NOTICE OF APPROVAL

Planning Case #: Design Study 20110

Project Description: Approval of Design Study (DS 20-110, Moha) authorizes site coverage and light fixture revisions to Design Study (DS 18-313, Moha-Essel) for the residence located on 8th Avenue 2 SE of Monte Verde in the R-1 Single Family Residential District. All project construction shall be performed in accordance with the project plans prepared by Adam Jeselnick Architect stamped approved and on-file at the Community Planning & Building Department, unless modified by the conditions of approval.

MOHA-ESSEL RESIDENCE
 8TH AVENUE 2 S/E OF MONTE VERDE,
 CARMEL-BY-THE-SEA, CALIFORNIA 93921

1 PROPOSED SITE PLAN
 SCALE: 1/4" = 1'-0"

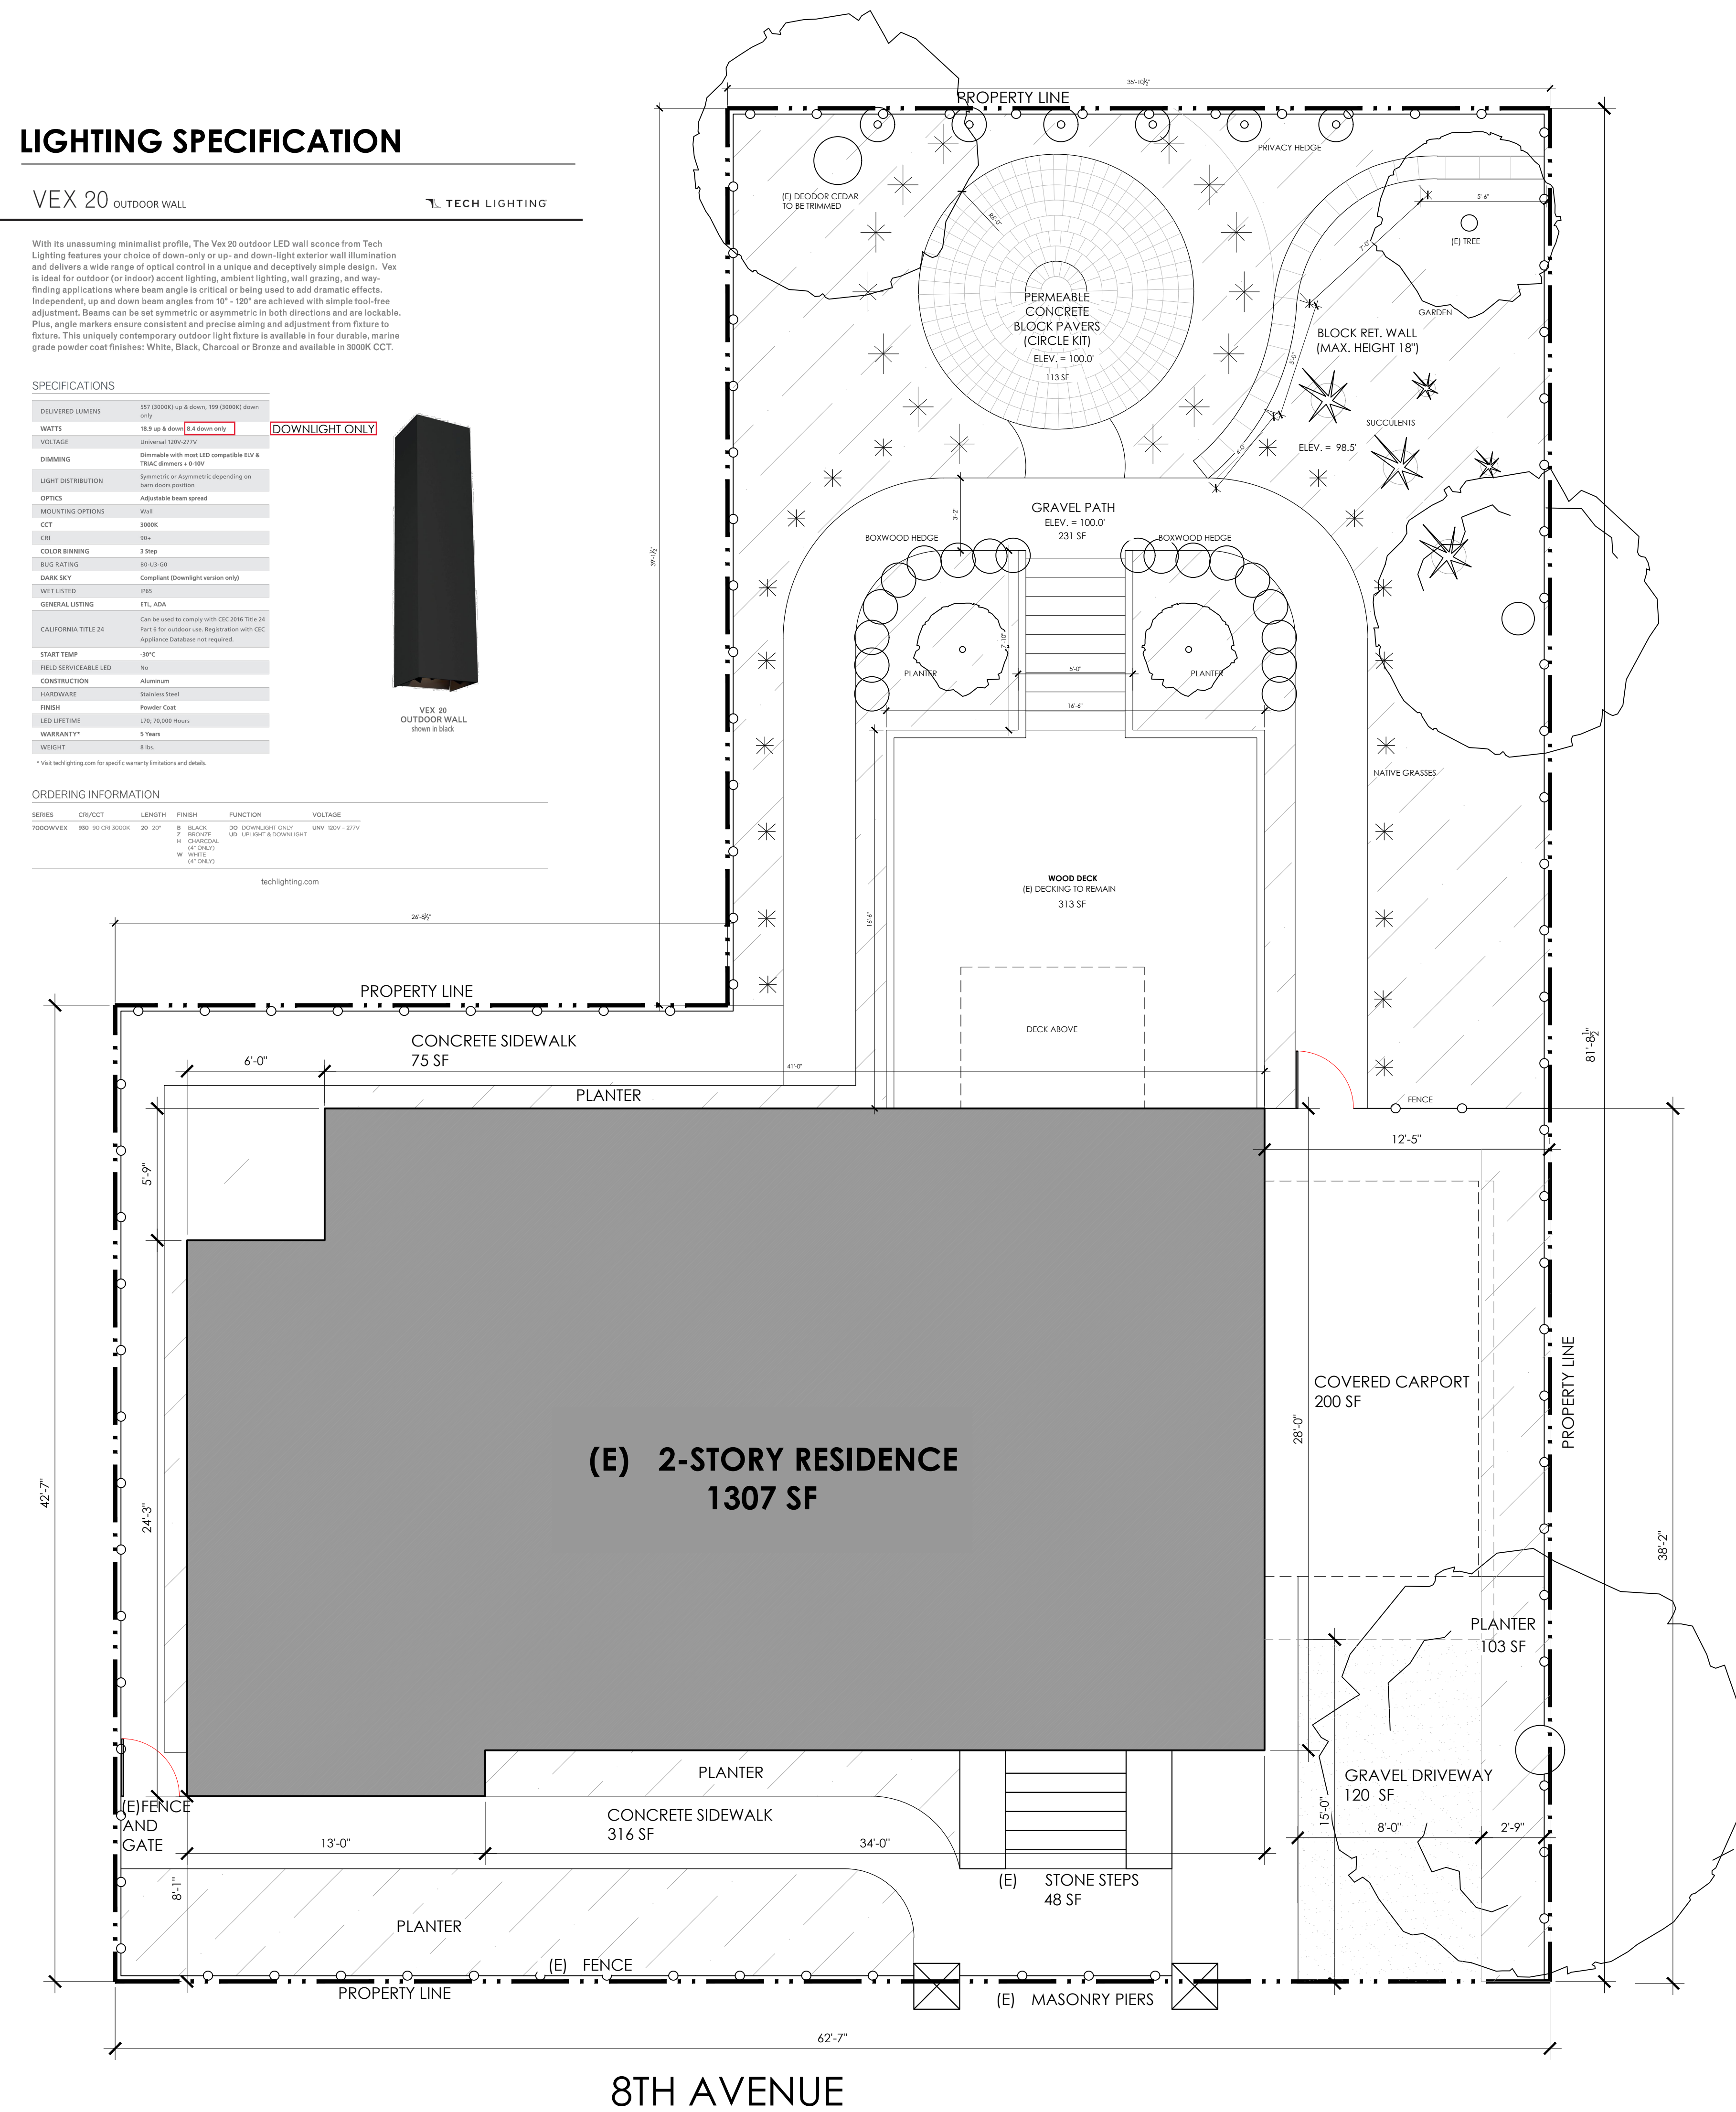
- REPLACE EXISTING EXTERIOR LIGHT FIXTURES TO MEET CODE MINIMUMS.
- MODIFY EXTERIOR SITE COVERAGE TO INCLUDE NEW PERMEABLE PAVER PATIO.

CARPORT / PARKING PAD	200 SF (NOT INCL. IN SITE COVERAGE)
DRIVEWAY	120 SF (PERMEABLE) [minus 113 SF]
FRONT WALKWAY	168 SF (PERMEABLE)
STONE STEPS	48 SF (IMPERMEABLE)
SIDE YARD CONC. WALK	145 SF (IMPERMEABLE)
REAR YARD CONC. WALK	75 SF (IMPERMEABLE)
REAR YARD GRAVEL PATH	231 SF (PERMEABLE)
WOOD DECK	313 SF (PERMEABLE)
REAR PAVER PATIO	113 SF (PERMEABLE) [adds 113 SF]
SITE COVERAGE (EXISTING)	1,213 SF TOTAL
<p>LOT AREA = 4,068 SF ALLOWABLE SITE COVERAGE = 401.5 SF + 163 SF (DRIVEWAY) = 564.5 SF*</p> <p>* SITE COVERAGE IS EXISTING NON-CONFORMING, NO CHANGE TO (E)</p>
